**CORINTH**

PROJECT NO.: BRO 1447(29)      PIN NO.:

ELASTOMERIC BEARING ASSEMBLY DETAILS

DWG NO: AC14A1R0      SHEET 1 OF 1

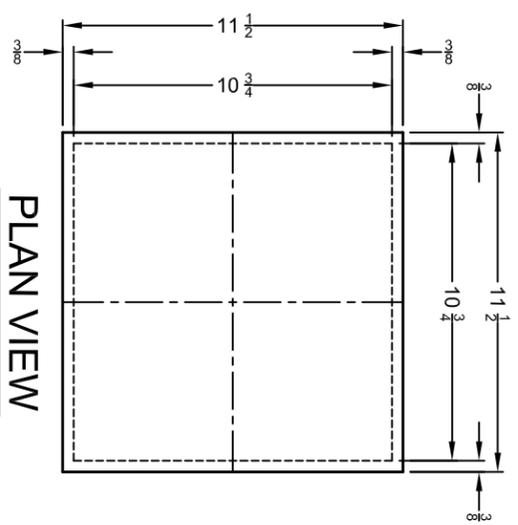
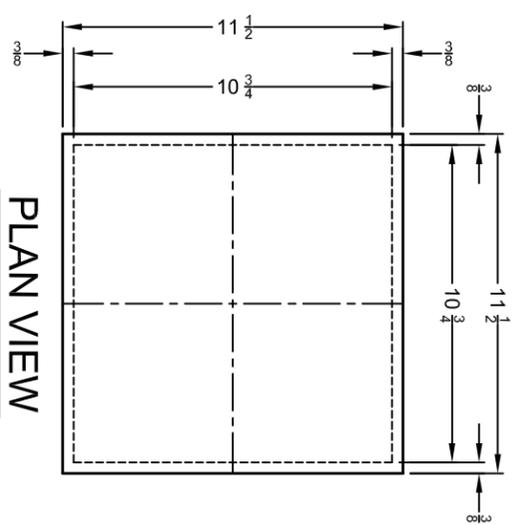
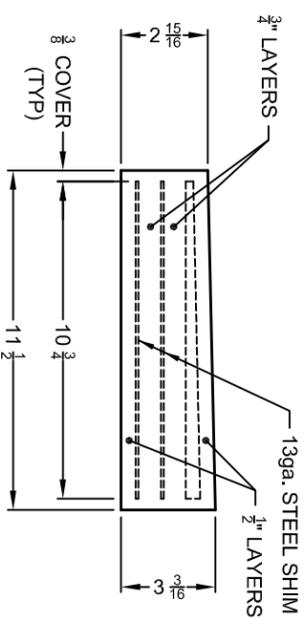
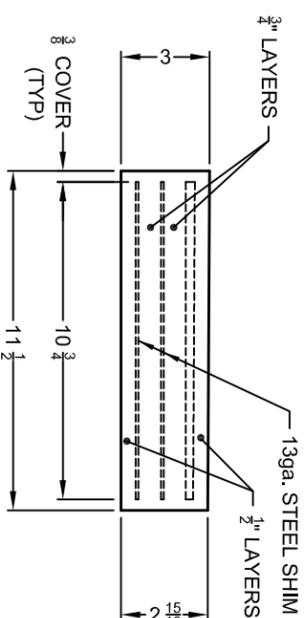
Add direction of stationing for both bearings
